APPLICATION NO.	FILING DATE	FIRST NAMED INVENTOR	ATTORNEY DOCKET NO.	CONFIRMATION NO.
10/010,149	11/12/2001	Robert F. Evans	FCI-2580/C2977	7215

Office Action Summary

DETAILED ACTION

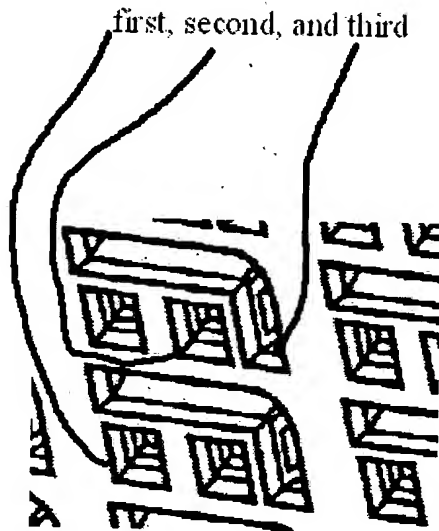
-- In reference to claim 21, Kline shows (cover sheet)

the plurality of receptacle contacts 24 are substantially cylindrical shaped.

-- In reference to claim 22, Kline shows ((cover sheet) and (figure 6) the plurality of receptacle contacts are arranged into an array of rows and columns.

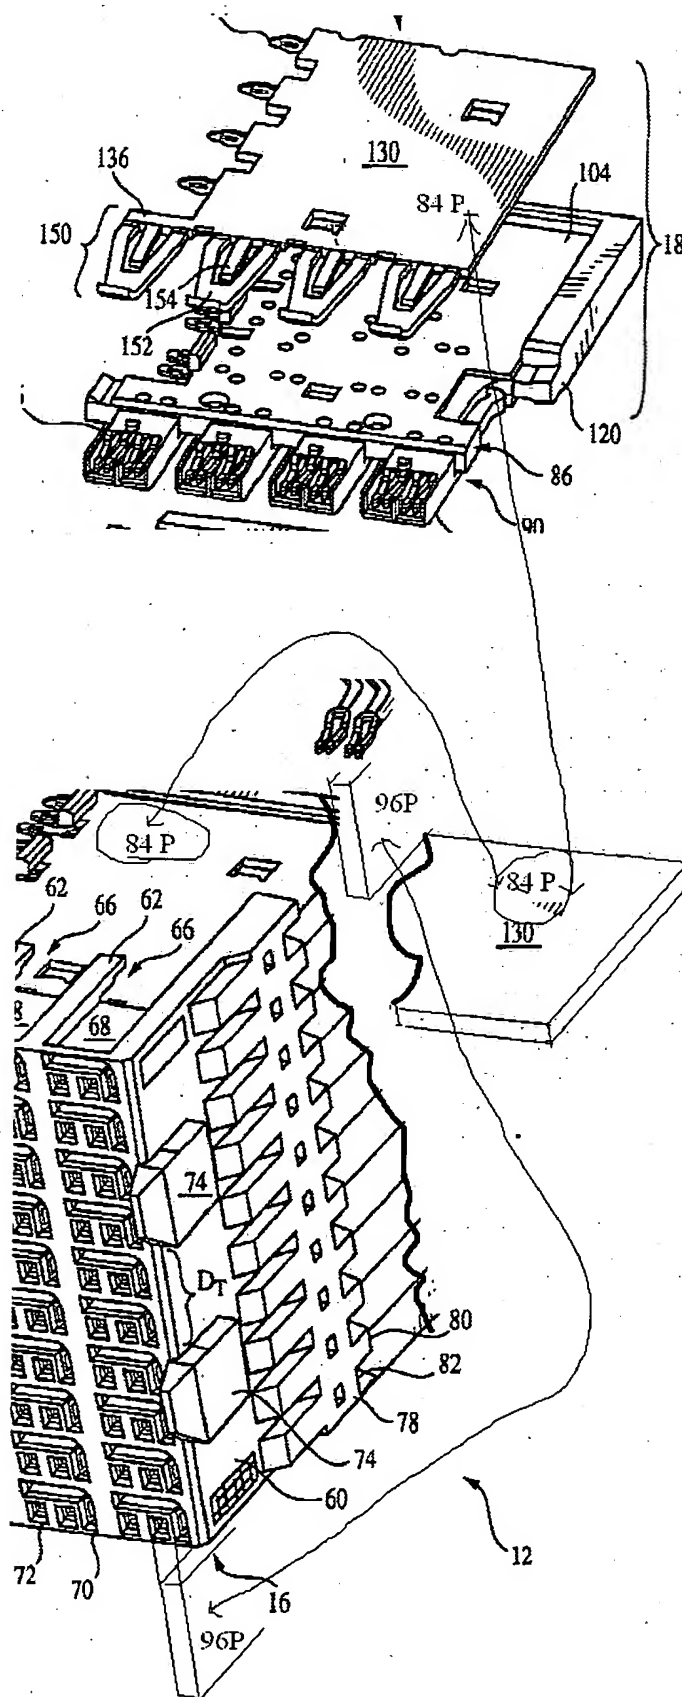
-- In reference to claim 23, Kline shows (see examiner's figure) the columns are arranged in repeating patterns of first, second, and third columns and the first and second columns are spaced farther apart than the second and third columns.

-- In response to applicant's argument (page 8, lines 12-15) concerning that Kline does not disclose or suggest an electrical connector having each pair of signal contact pins defining a plane substantially orthogonal to the ground plane, the examiner disagrees. Applicant's mark up of the examiner's figure is noted highlighting plane 96P'. Applicant's example of plane 96P' showing a second plane in a 3 dimensional figure is seen to further explain the rejection. The contact pins 96 have a thickness and a width. The width defines plane 96P' and the thickness defines plane 96P.
